**PARK CITY REGULAR PLANNING COMMISSION MEETING
SUMMIT COUNTY, UTAH
August 25, 2021**

7.A. Deer Valley Snow Park Proposal - Project Overview With Respect to Parking and Site Circulation. PL-21-04811.

Planning Commission Work Session Staff Report

Subject: Deer Valley Snow Park Base Area Development
Project #: PL-21-04811
Author: Alexandra Ananth – Senior Planner
Date: August 25, 2021
Type of Item: Work Session – Project Orientation

Contextual Circulation Plan

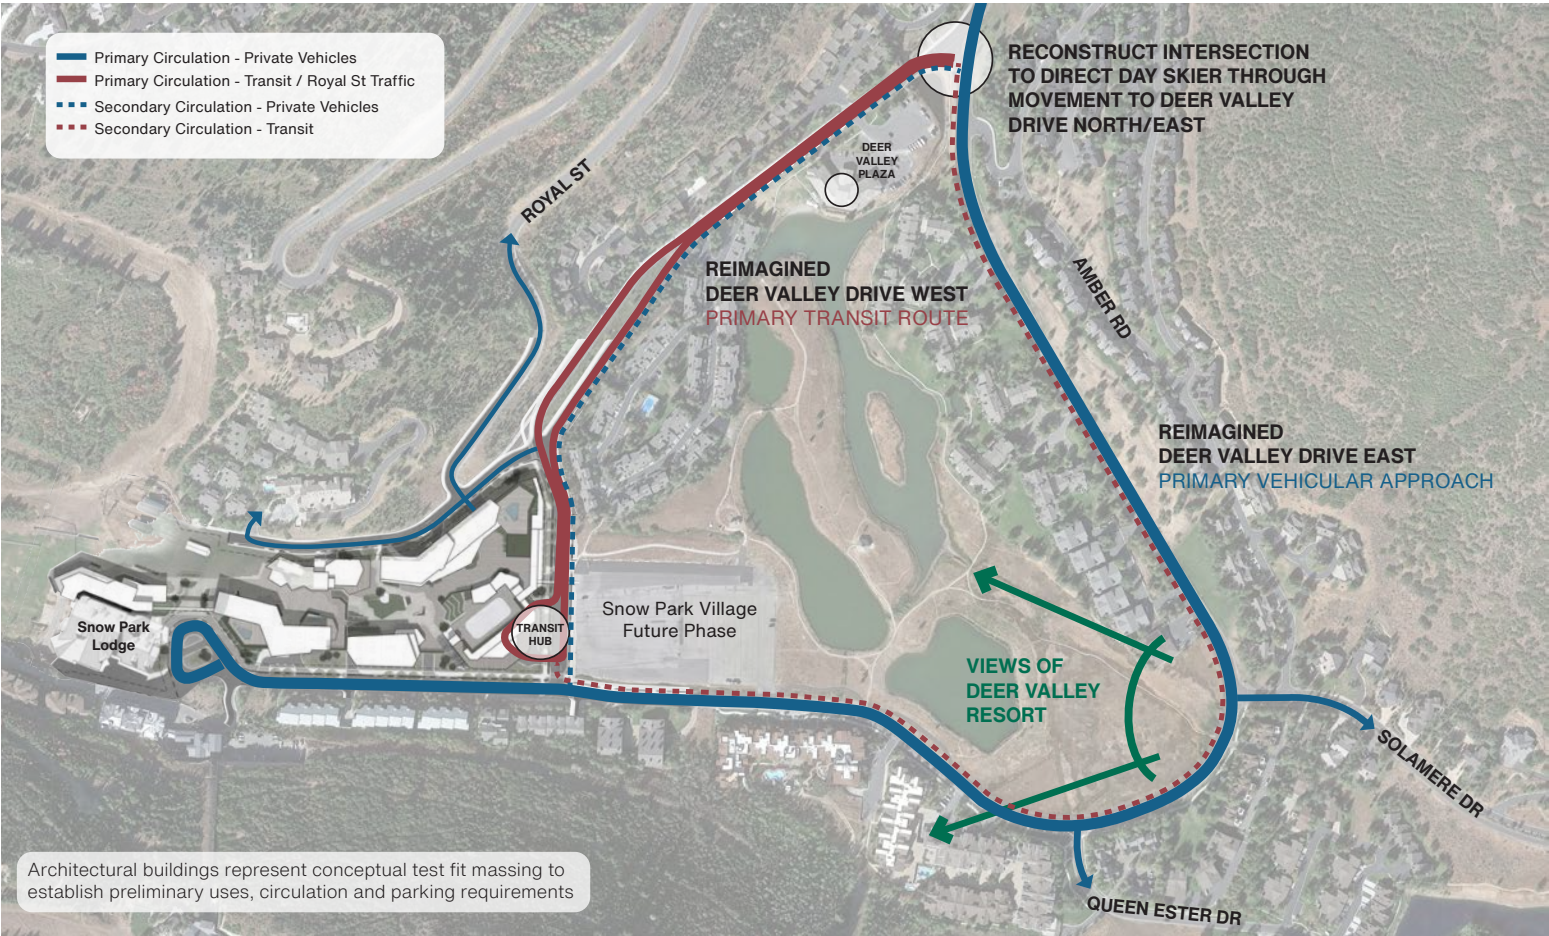
Deer Valley Drive is a popular walking and biking loop, and the applicant should clarify if a multi-use path will maintain this loop for pedestrians and bicyclists. Path details must be submitted to the City and should include existing and proposed pedestrian and bike paths.

Exhibit 10: **Parking Garage & Floor Plans**
P1 - Elevation 7150'

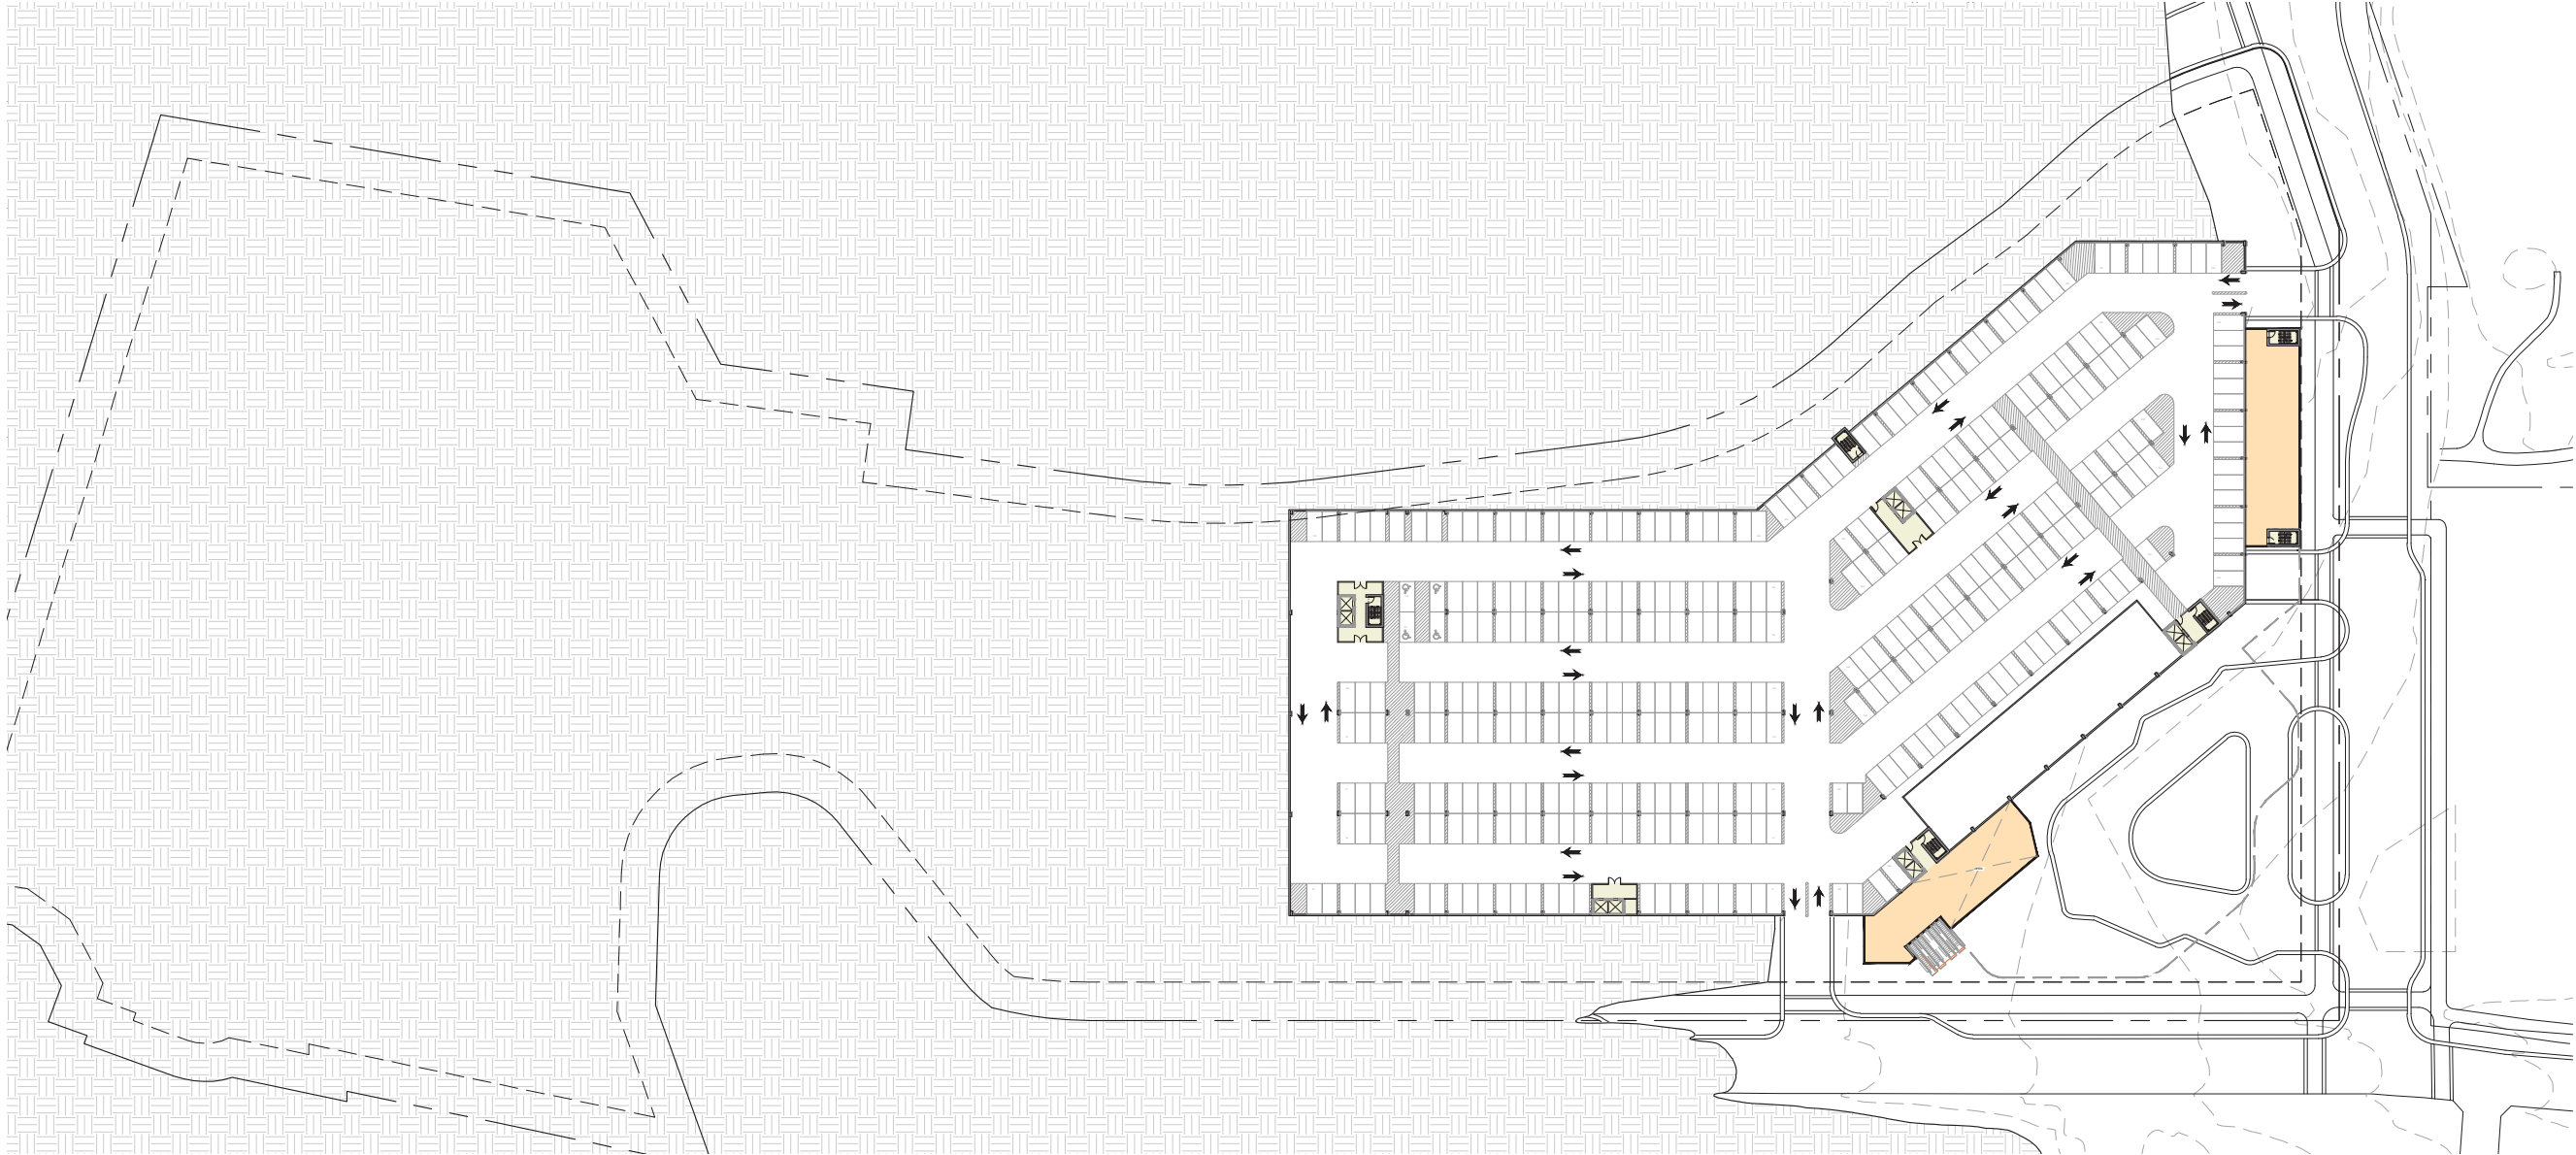
The garage has four levels with multiple entrances to most levels. ***The Planning Department notes that the only entrance to level P1 is on Doe Pass Road, close to the Mobility Hub. Staff is concerned that this may create congestion and conflicts with public transportation, and this must be reviewed more closely by the applicant and the City's transportation consultant.***
